**VOLLMER ROAD RV AND BOAT STORAGE**  
 SCOTT BELLKNAP scott.bellknap@yahoo.com  
 PROJECT ADDRESS: 8815 VOLLMER ROAD  
 COLORADO SPRINGS, CO 80908  
 LANDSCAPE PLAN

SHEET TITLE:  
**LANDSCAPE PLAN**

FILE NO.  
PPR-2245

# Landscape Plan Drawings\_V2.pdf Markup Summary

PLAN SCALE: \_\_\_\_\_  
SHEET TITLE: **LANDSCAPE DETAILS**  
SHEET NO. **2**  
2 OF 2 SHEETS  
FILE NO. **PPR-2245**

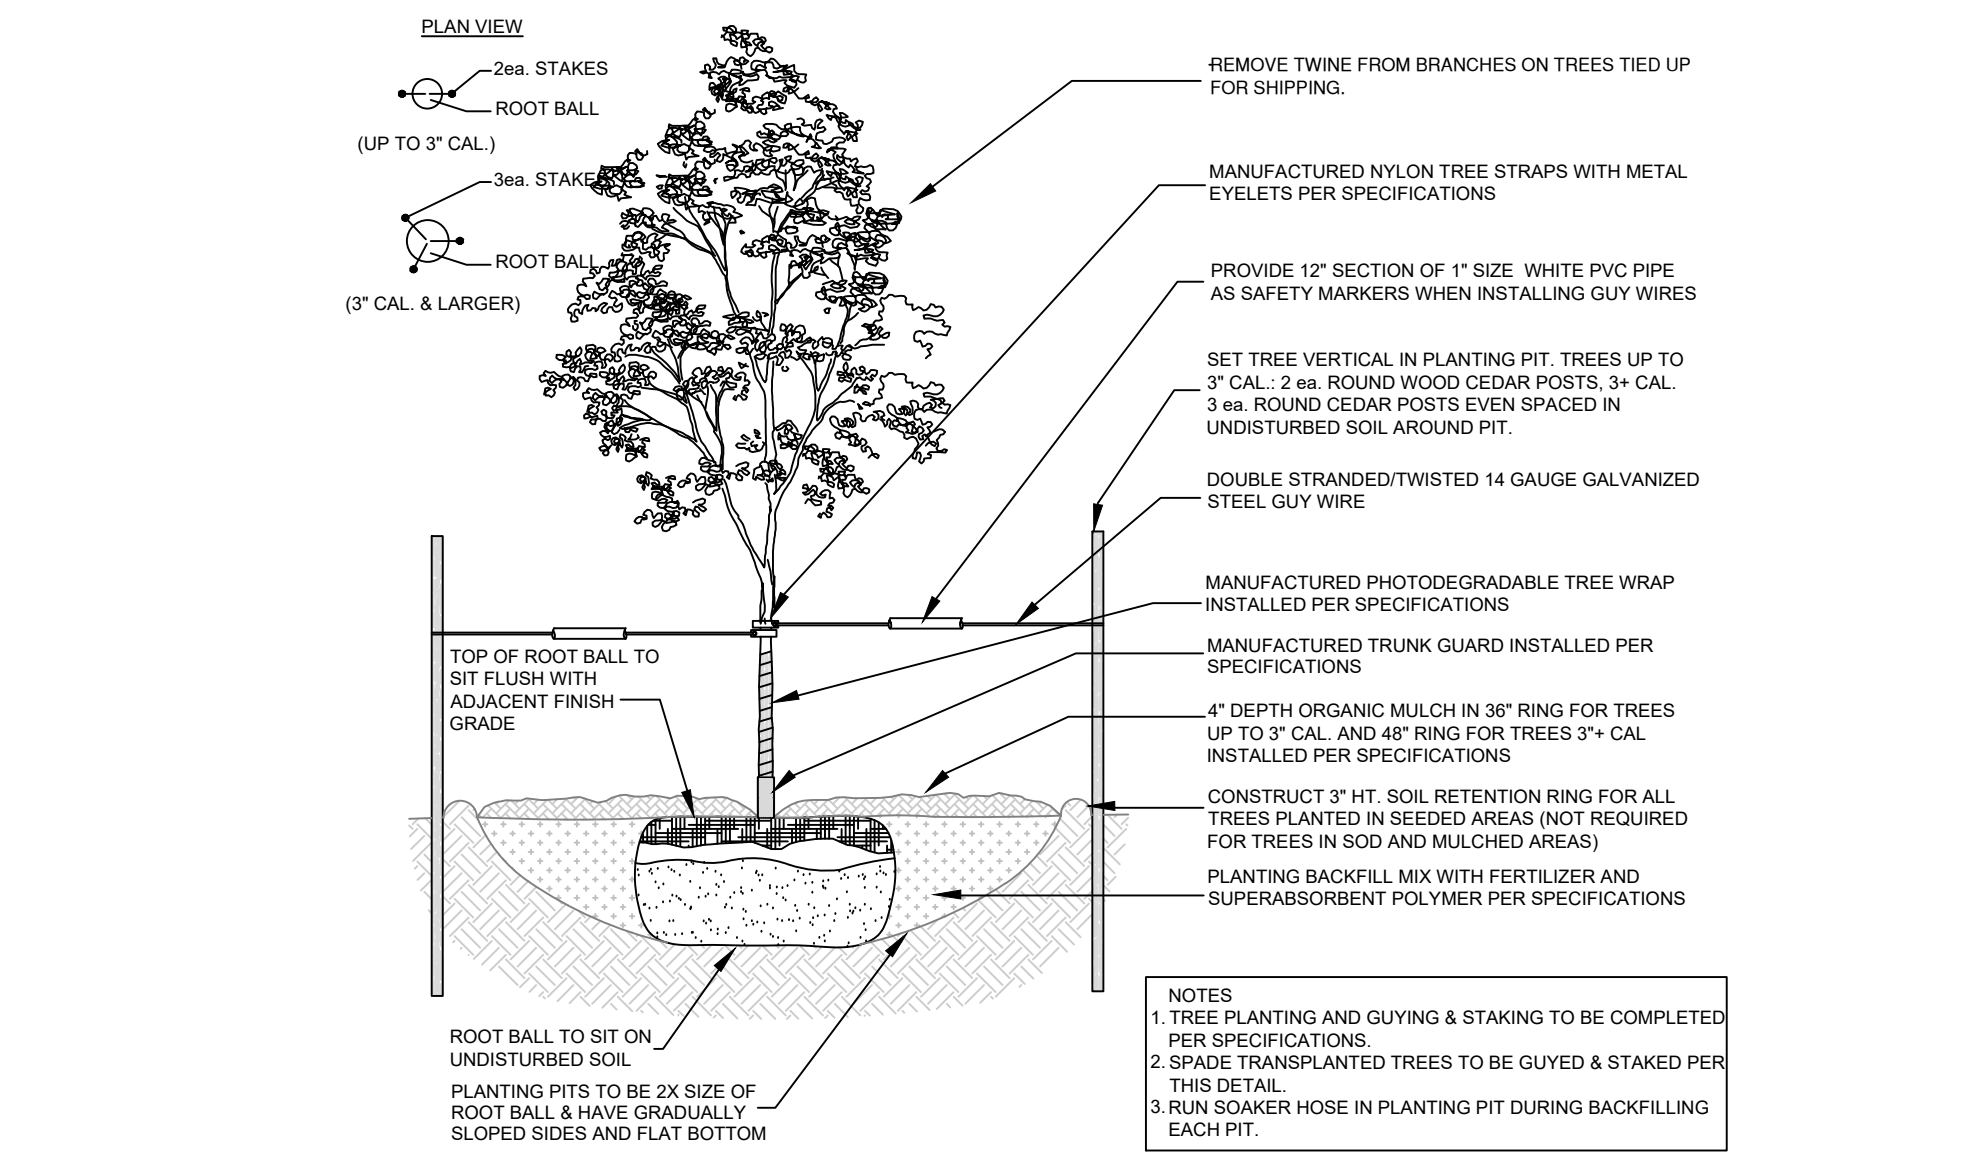
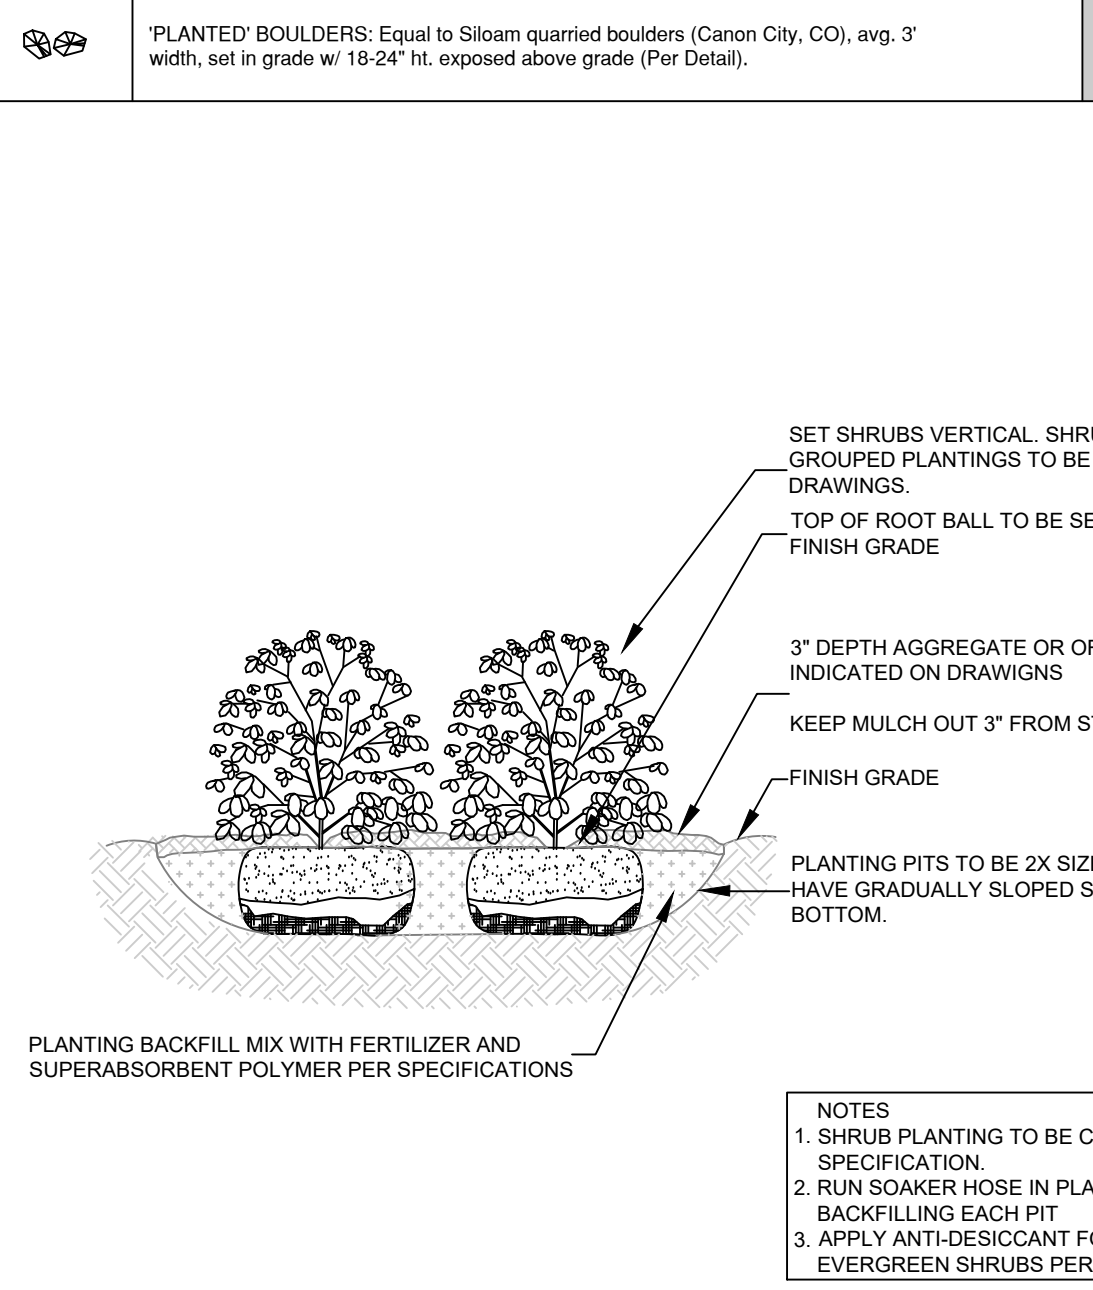
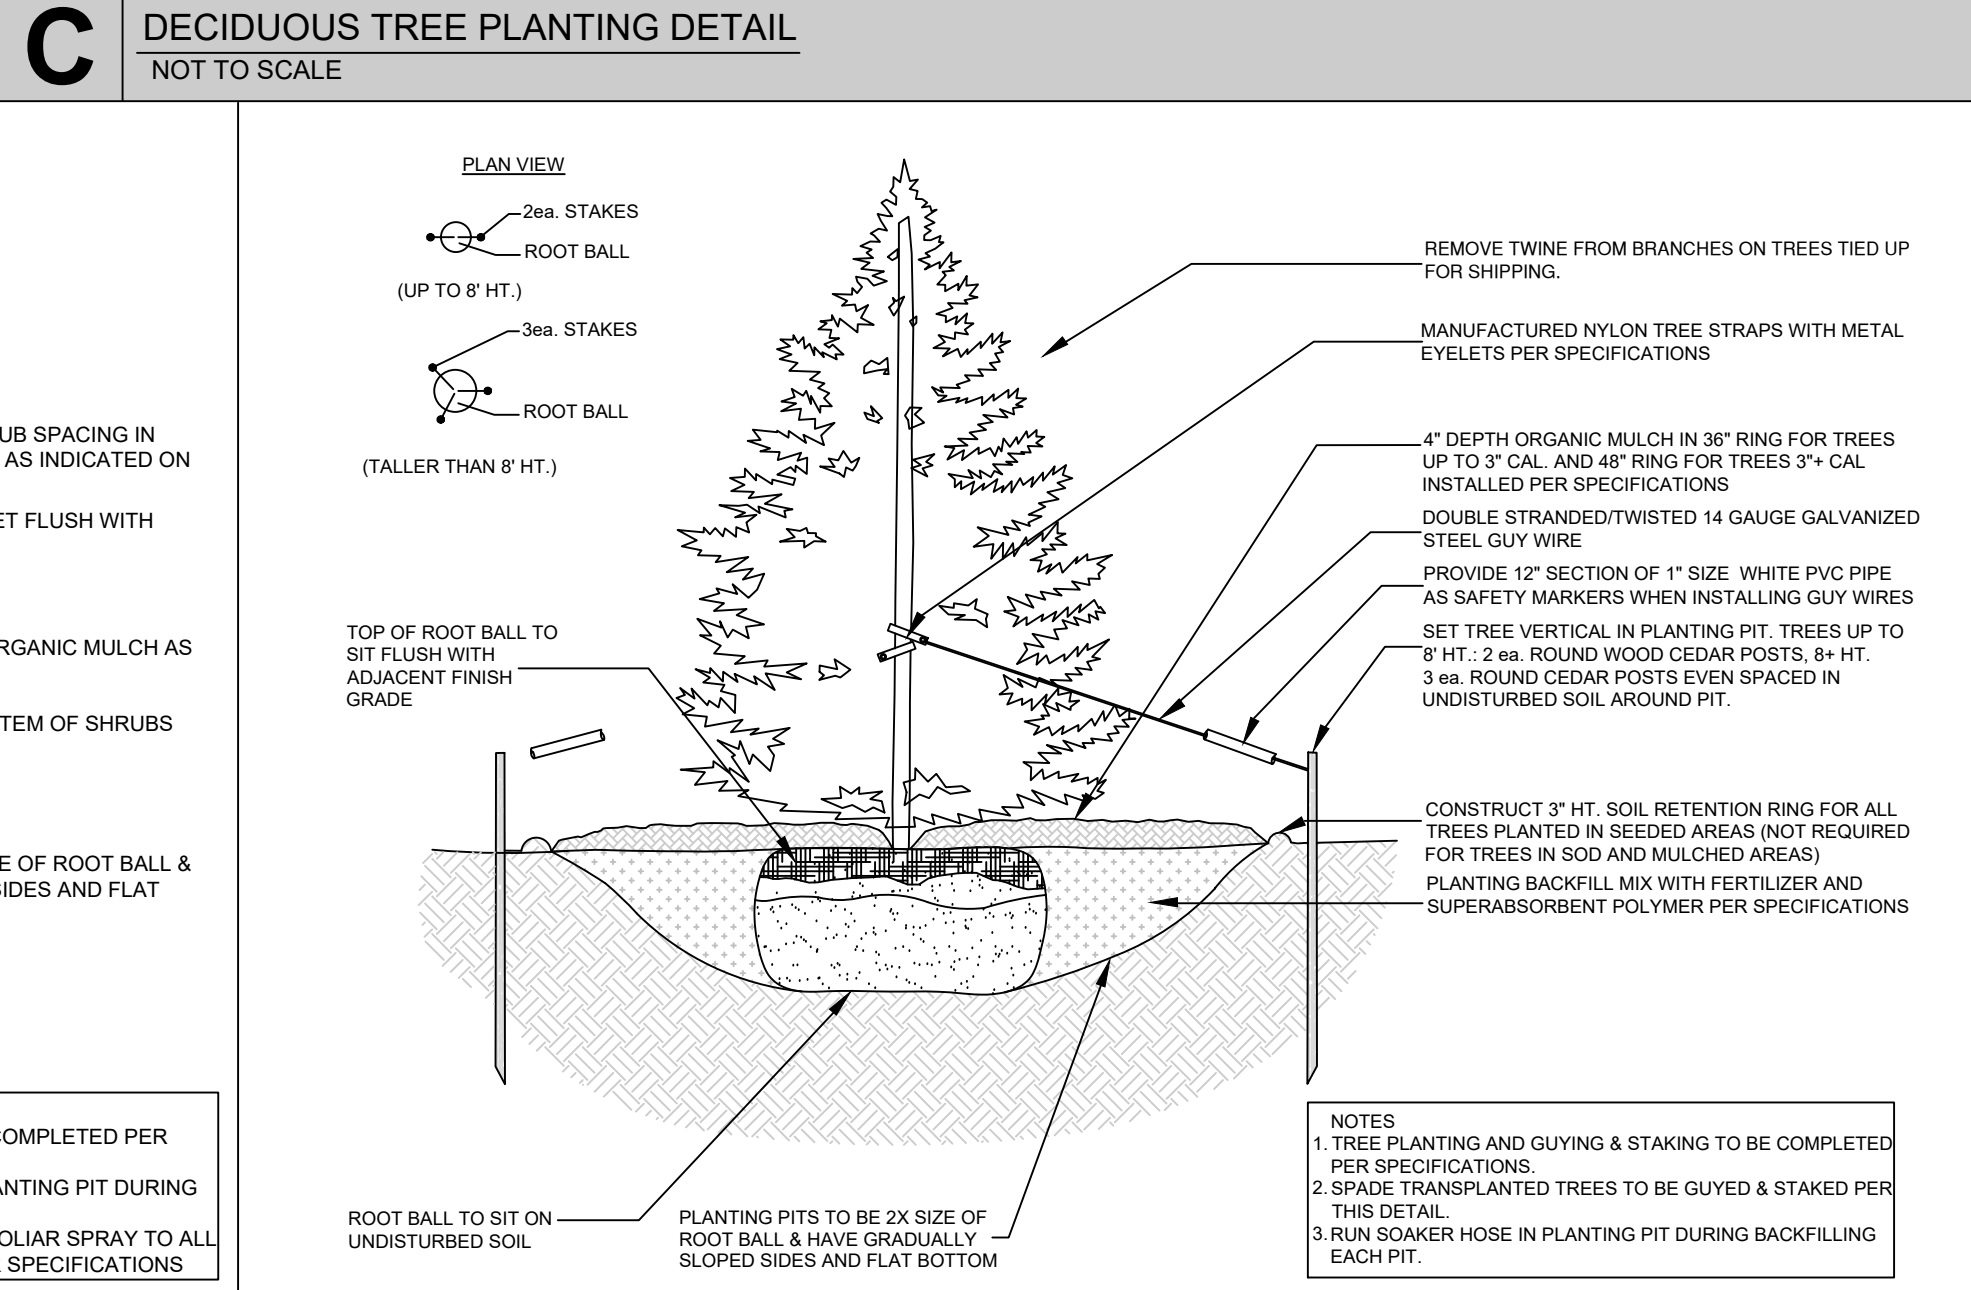
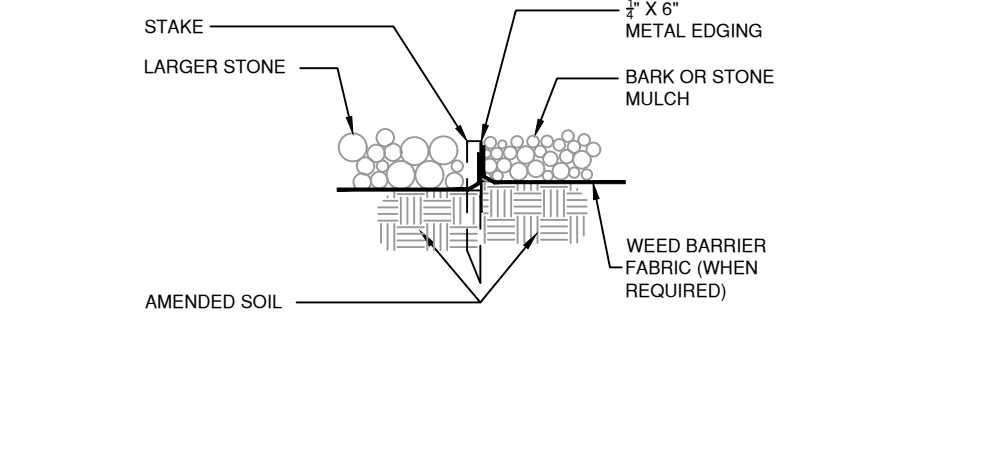
Provide owner name, contact information to match sheet 1

Update to Landscape Plan

Update to match sheet 1

**Subject:** Callout  
**Page Label:** [2] Vollmer Road RV and Boat Storage LS\_IR alt Update to Landscape Plan  
9-LS2  
**Author:** Linda.Nguyen  
**Date:** 11/21/2022 4:19:01 PM  
**Status:**  
**Color:** ■  
**Layer:**  
**Space:**

**Subject:** Callout  
**Page Label:** [2] Vollmer Road RV and Boat Storage LS\_IR alt Update to match sheet 1  
9-LS2  
**Author:** Linda.Nguyen  
**Date:** 11/21/2022 4:20:10 PM  
**Status:**  
**Color:** ■  
**Layer:**  
**Space:**

**Subject:** Callout  
**Page Label:** [2] Vollmer Road RV and Boat Storage LS\_IR alt Provide owner name, contact information to match sheet 1  
9-LS2  
**Author:** Linda.Nguyen  
**Date:** 11/21/2022 4:20:14 PM  
**Status:**  
**Color:** ■  
**Layer:**  
**Space:**
